SERVICE BULLETIN

EC20-021

NTB20-064

ALTIMA WITH PR25DD ENGINE; DTC P0015 STORED

Figure 1

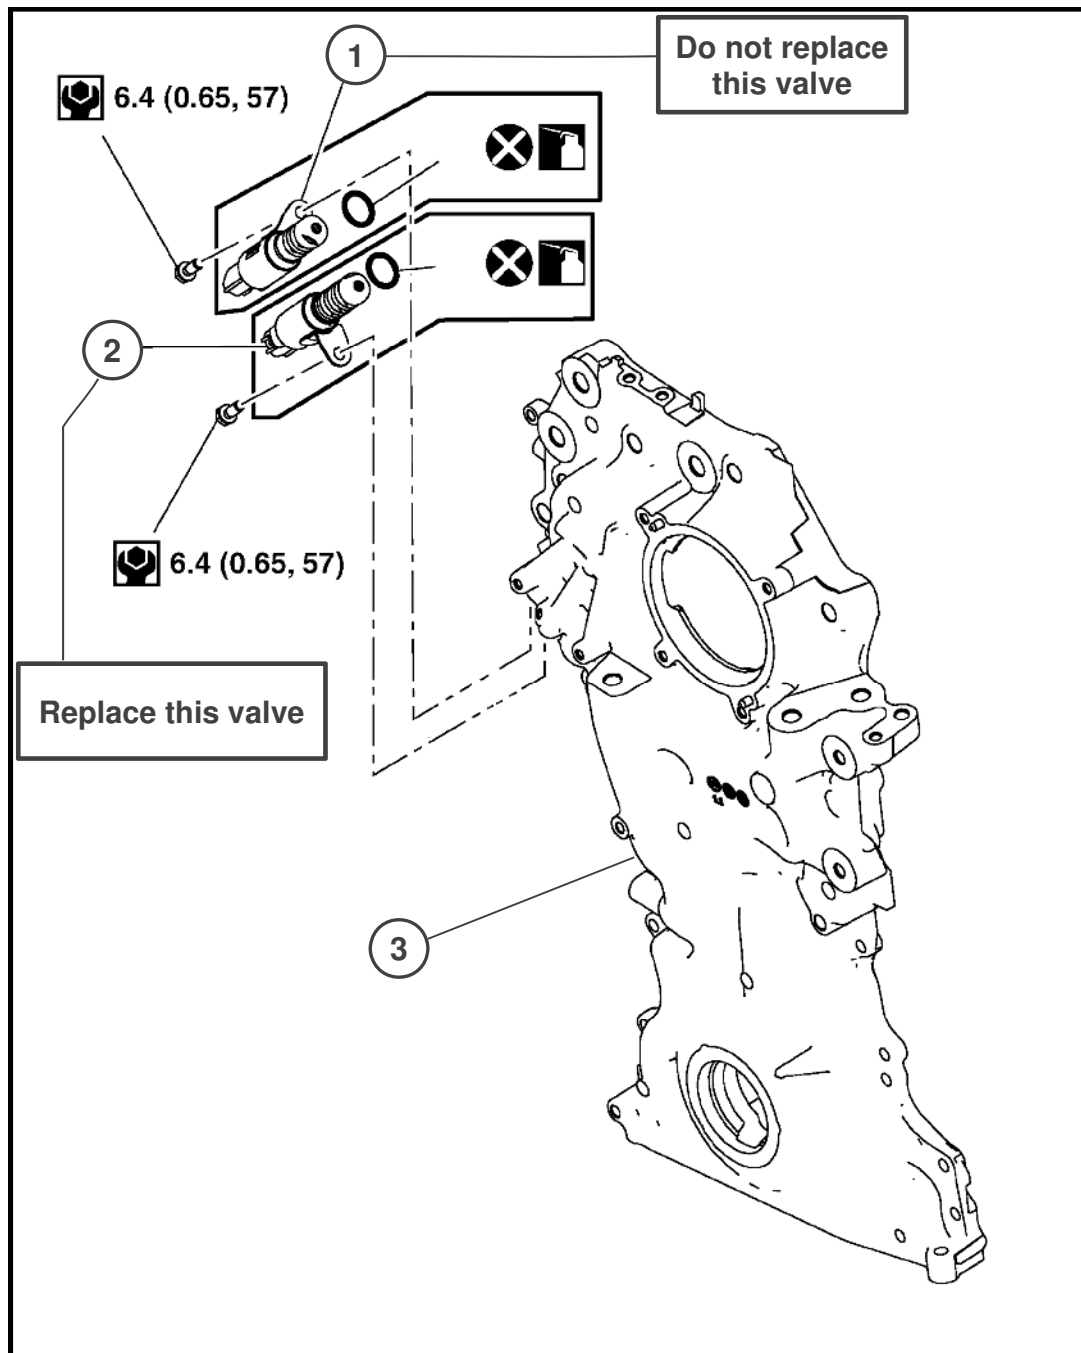
NOTE: The exploded views in the 2019 and 2020 Altima ESM may incorrectly label the exhaust valve timing control solenoid valve and the exhaust valve timing intermediate lock control solenoid valve. The exhaust valve timing control solenoid valve is positioned below the exhaust valve timing intermediate lock control solenoid valve on the front cover.

1. Replace the exhaust valve timing control solenoid valve and O-ring.
 - Refer to the ESM, section **ENGINE > ENGINE MECHANICAL > PR25DD > REMOVAL AND INSTALLATION > SOLENOID VALVE**.
